Project **IEEE 802.16 Broadband Wireless Access Working Group** <<http://ieee802.org/16>>

Title **Clarify the EAP based Authentication Procedure**

Contribution on comments to P802.16g-D1

Clarification on EAP Based Authentication Procedure Diagram

Figure 477—EAP based Authentication Procedure

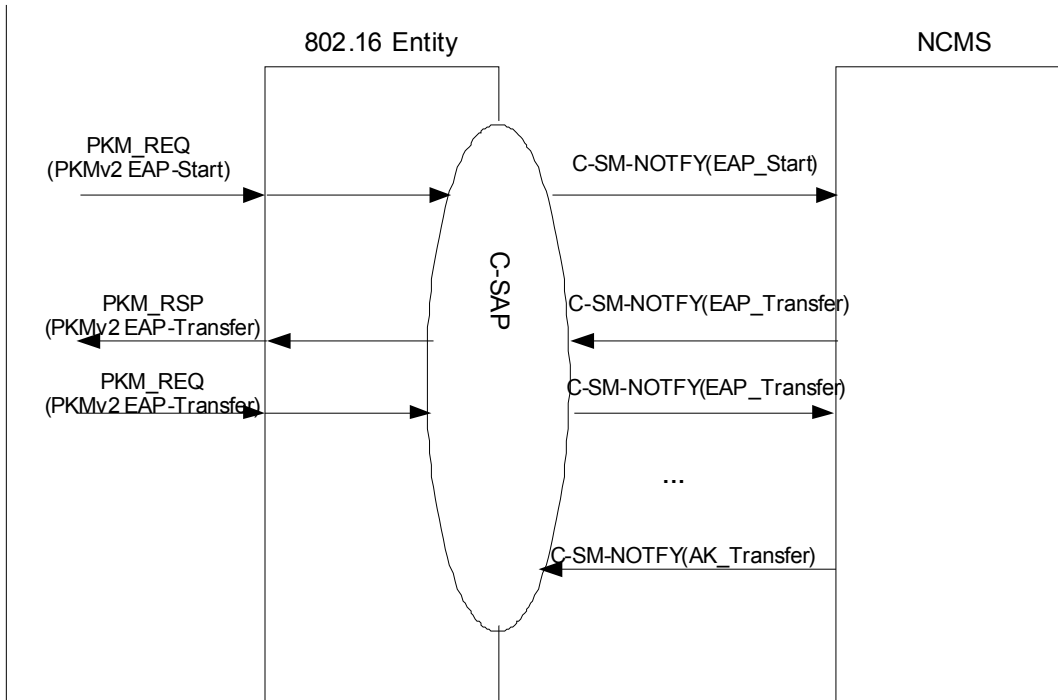
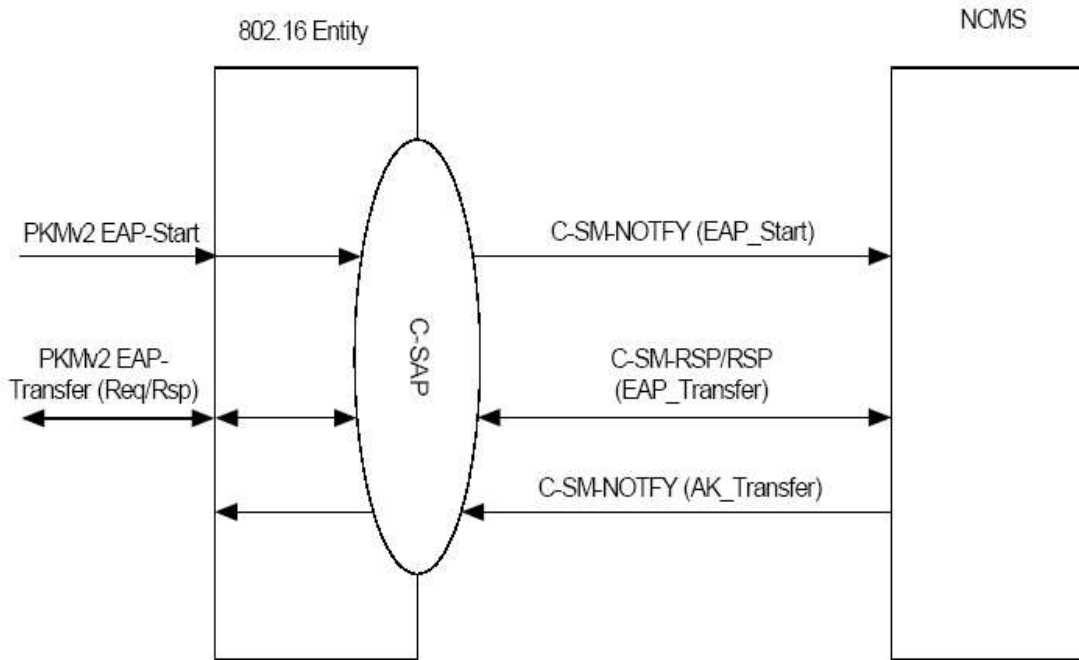
In Section 14.2.5.1 (EAP based authentication procedures), Figure 477, it is confused to use bi-direction arrow line to show interaction between 802.16 Entity and NCMS. It is hard to tell sequence of the call flow. Based on EAP specification, ~~the C_SM_REQ is sent from NCMS to 802.16 Entity. The 802.16 Entity will send C_SM_RSP in response to it. It~~ is better to separate them by C_SM_NOTIFY, which will make the flow more accurate.

This contribution clarifies the primitive diagrams by separating changing the C_SM_REQ/RSP primitive into two unidirectional arrow line C_SM_NOTIFY.

[Modify section 14.2.5.1, replace Figure 477 with the following figures]
